SOUTH BAY BRIDGE
S.H. 9113, WHITEHALL-DRESDEN
Route 22
WASHINGTON COUNTY

FIELD CHANGE SHEET

SHEET 26-F1 SUPERCEDES SHEET NO. 26 DUE TO THE FOLLOWING REASONS:

FIELD CHANGE SHEET

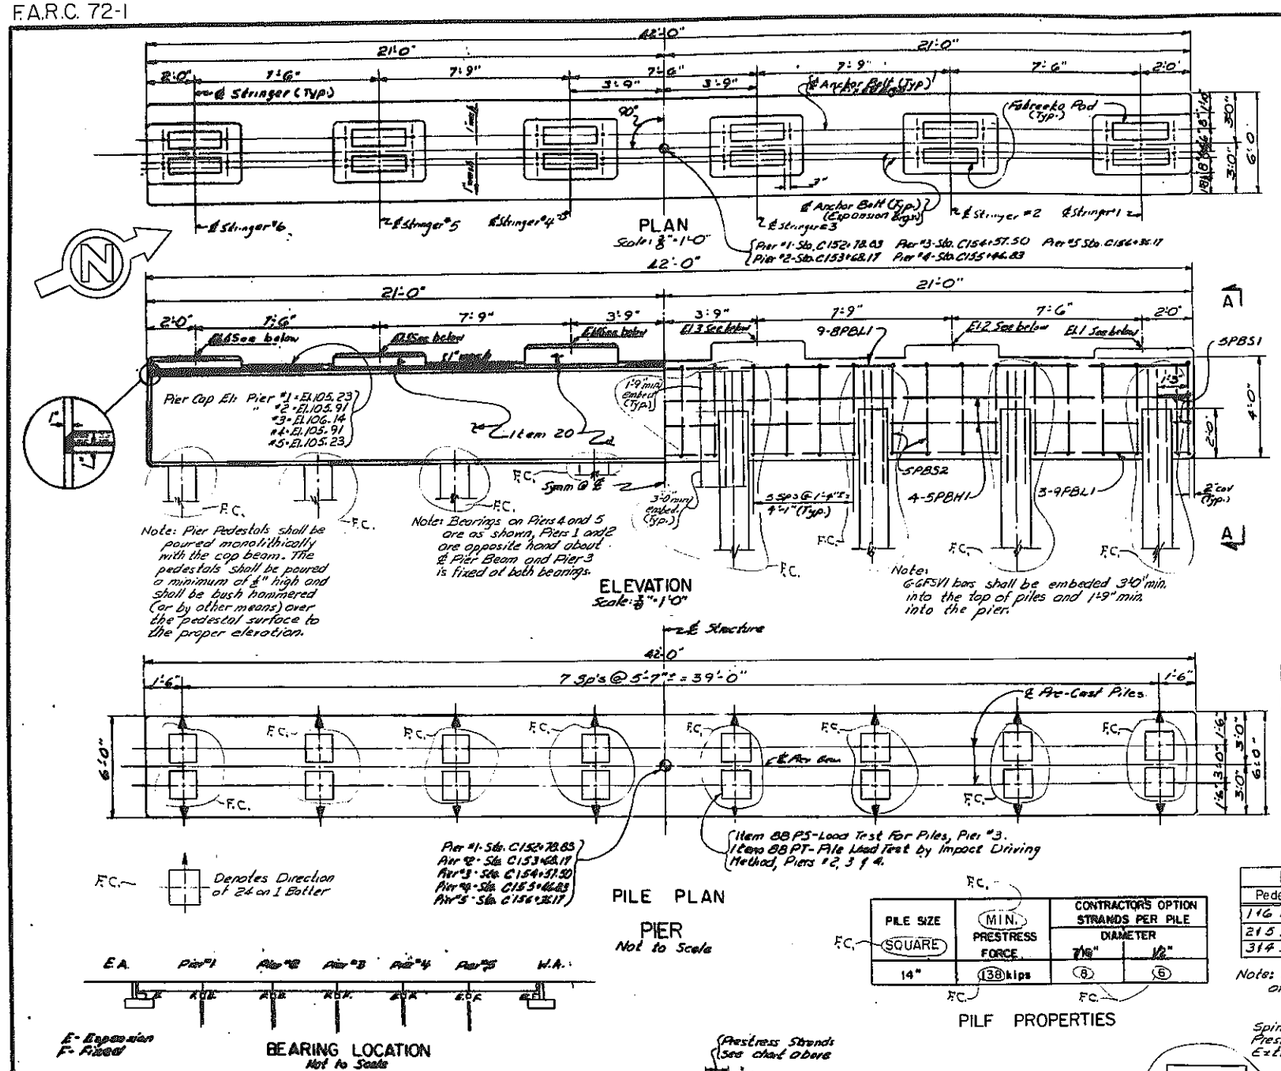
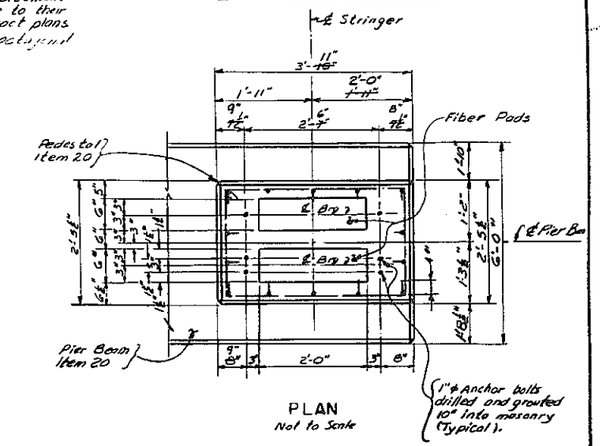
1. The addition of GFSV1 bar reinforcement in the top of the pile was due to their omission on the original contract plans.
2. Change in pile section from octagonal to square.

BAR LIST					
MARK	SIZE	NO.	LGTH	TYPE	LOCATION
GFSV1	6	480	4'-9"	Str.	Vert. Top of Pile

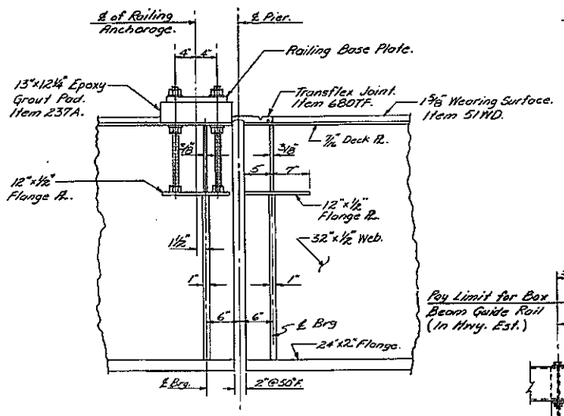
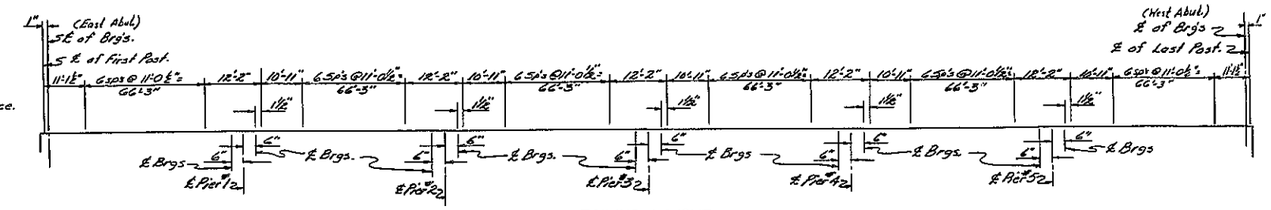
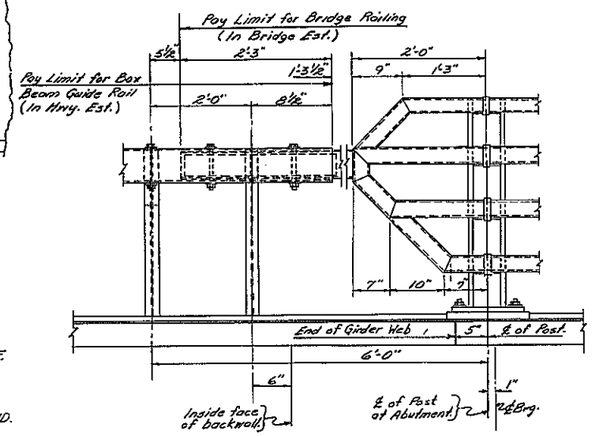
CHANGE IN QUANTITIES					
ITEM	DESCRIPTION	UNIT	INCREASE	DECREASE	NET CH'GE
680TF	Transflex Expansion Joint	L.F.	0	10	-10

NOTE: This sheet does not supersede sheet 30, it is a supplement to sheet 30.

FIELD CHANGE SHEET

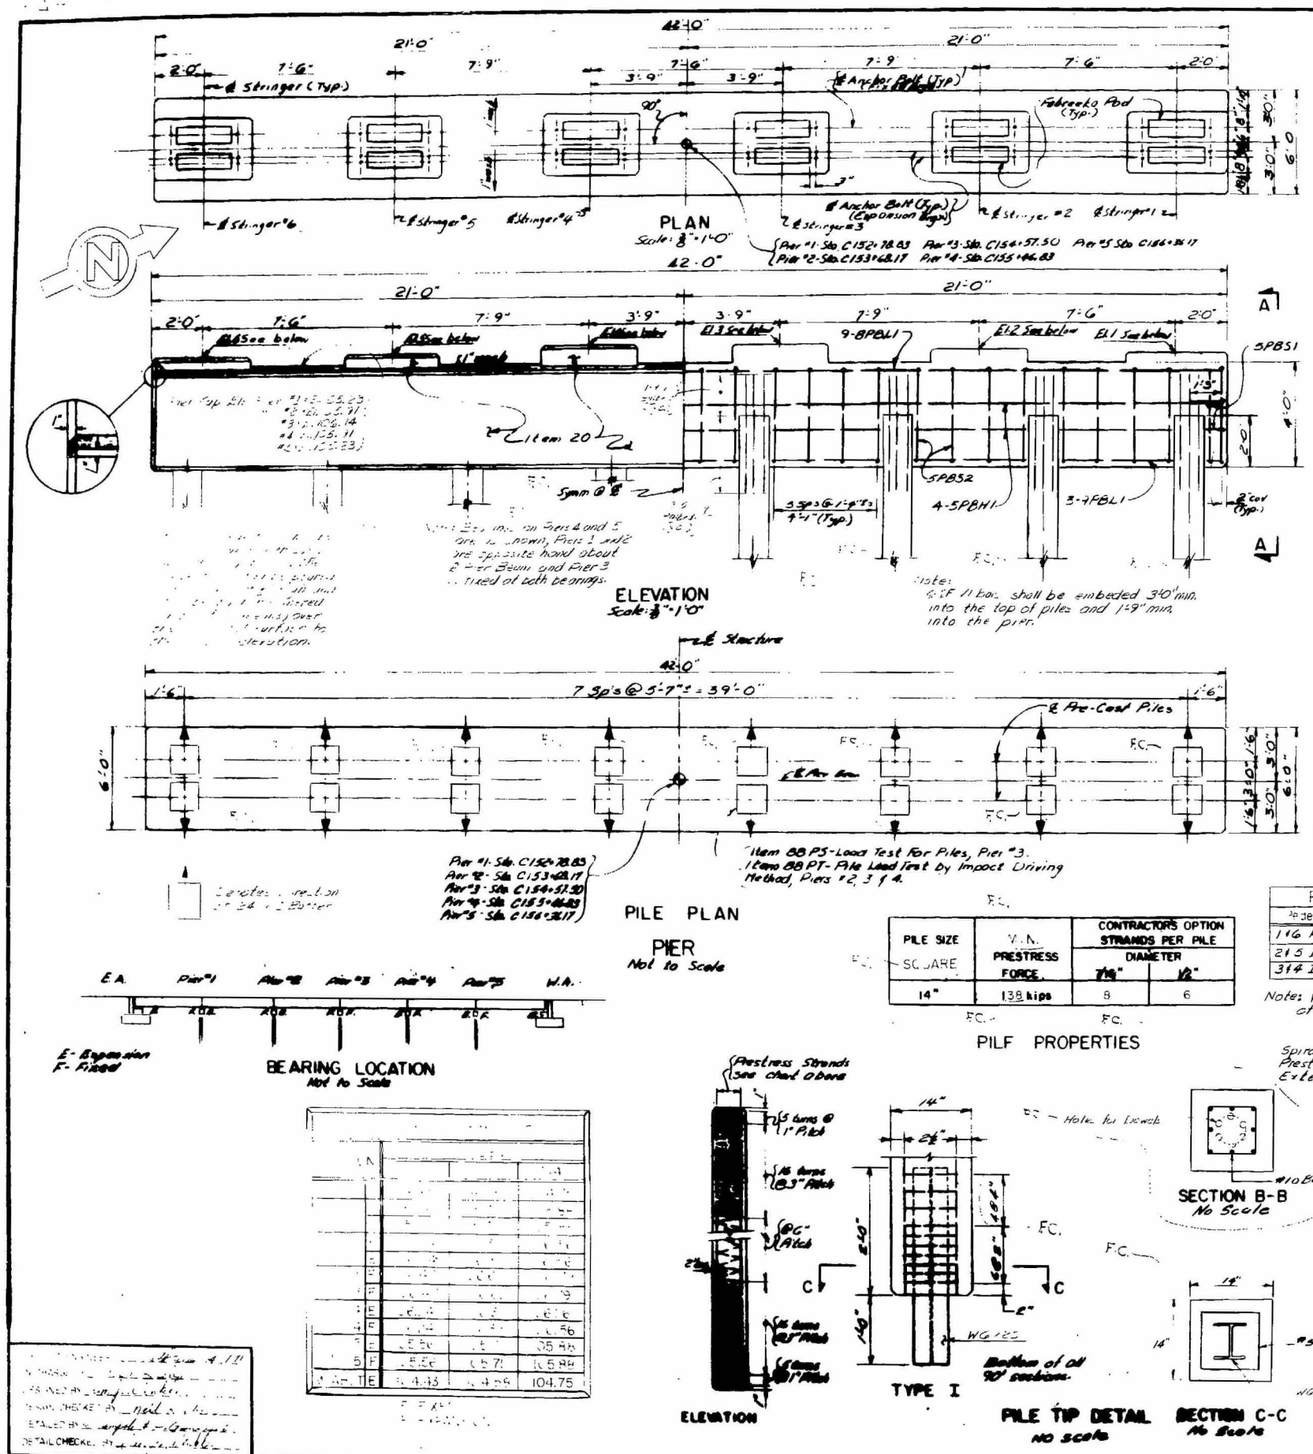
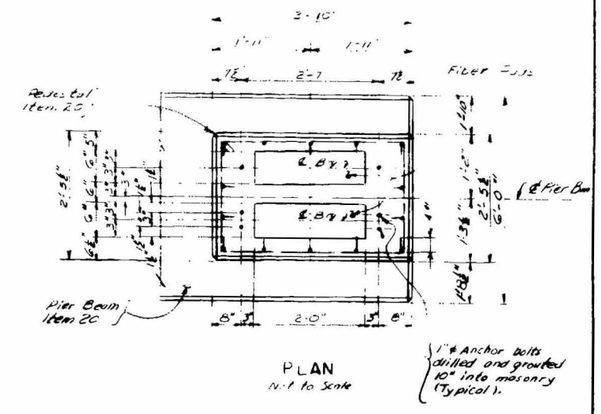
1. The addition of 28 #5 bar reinforcement in the top of the pile was due to the omission on the original contract plans.
2. [illegible]

BAR LIST					
MARK	SIZE	NO.	LGTH	TYPE	LOCATION
GPSV1	6	480	4'-9"	Str.	Vert. Top of Pile
